Historic Landmarks and Preservation Districts Commission

Report to Committee

Case No: 23-COA-0018
Classification: Committee Review

Property Address: 285 Pope St.

Figure 1 and 2. Designation Photos of 285 Pope St.

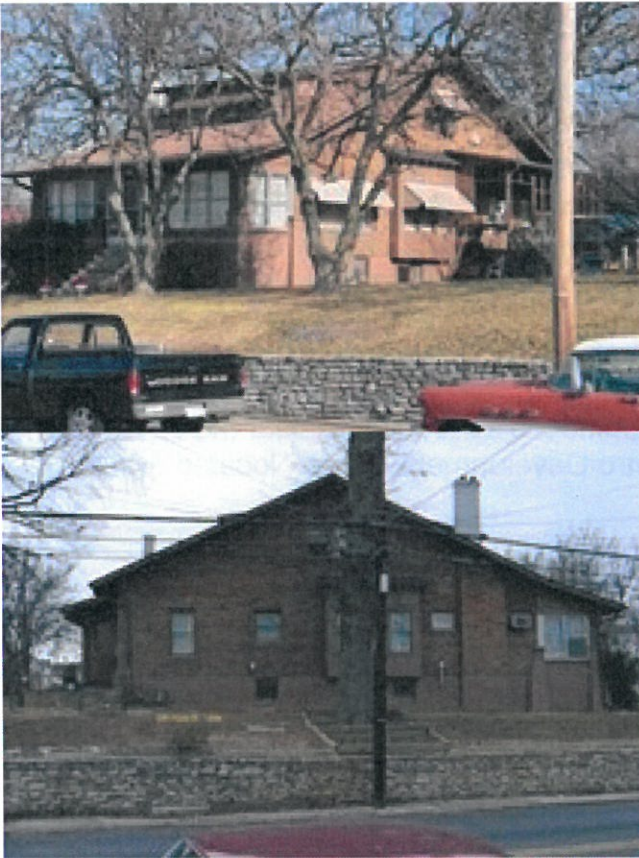
The project generally does not meet the Clifton Preservation District design guidelines for **Paint and Coatings** and **Masonry**. The brick on the house and garage had never been painted (**Figure 1 and 2 below**), with the exception of the porch parapet walls, porch columns, chimney, and first level bay projections. Thus its painting does not conform with guidelines **P1** and **M1** (**Figure 3 below**).

1. The paint shall be removed from the bricks. The applicant shall test gentle treatments to remove the paint in an inconspicuous location.
2. Landmarks staff shall be consulted for recommended products. The applicant shall not sandblast, pressure wash or use acid-based cleaners to remove the paint. Solvent-based chemical strippers are preferred over sandblasting or pressure washing the masonry surface.
